Service Bulletin

No 20 rev 1 2017-05-29

Flocbooster hose kit for dosage pump (PN 17037, 17039)

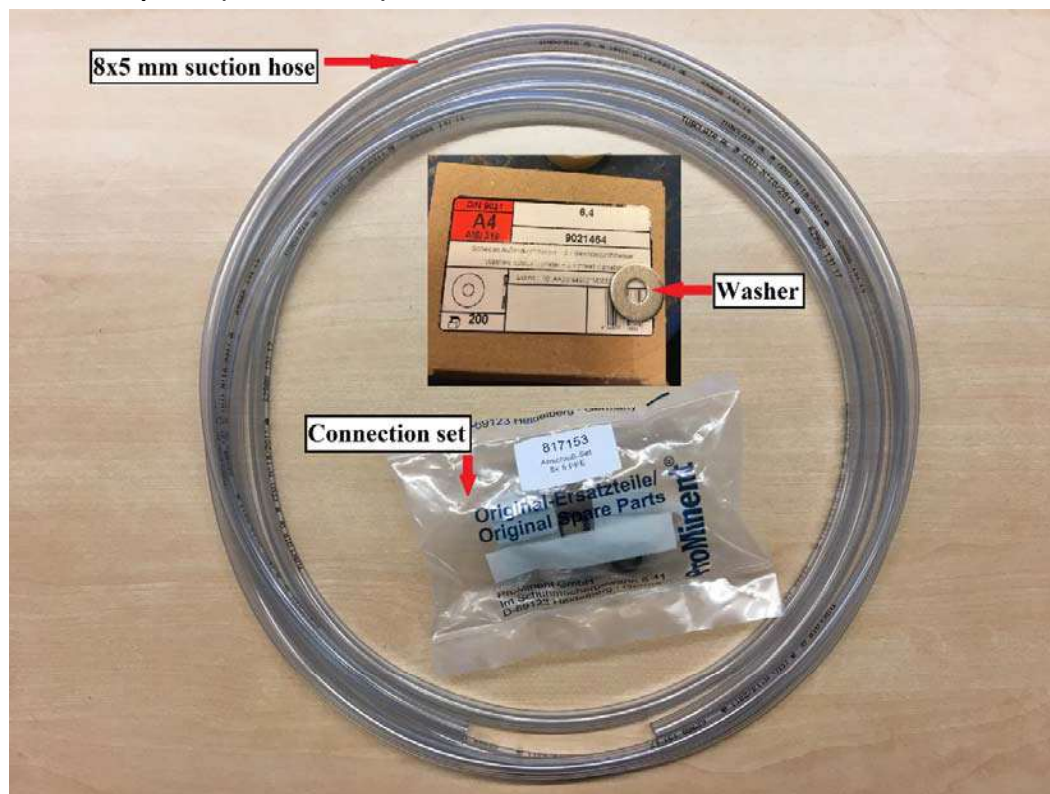
Under particular circumstances, such as prolonged operation interval, pumping of the Flocbooster may become inefficient. To improve pump efficiency, we recommend upgrading the pump suction line with the below described KIT having Part Number 17026-1.

The pump will work more efficiently regardless of the viscosity of the chemical and reduce the need of replacing the complete pump hose KIT.

- Dismantle the existing suction hose from the Flocbooster dosage pump and replace it with the 8x5 mm hose and connection set provided
- Replace the strainer in the foot valve with the washer as per below picture
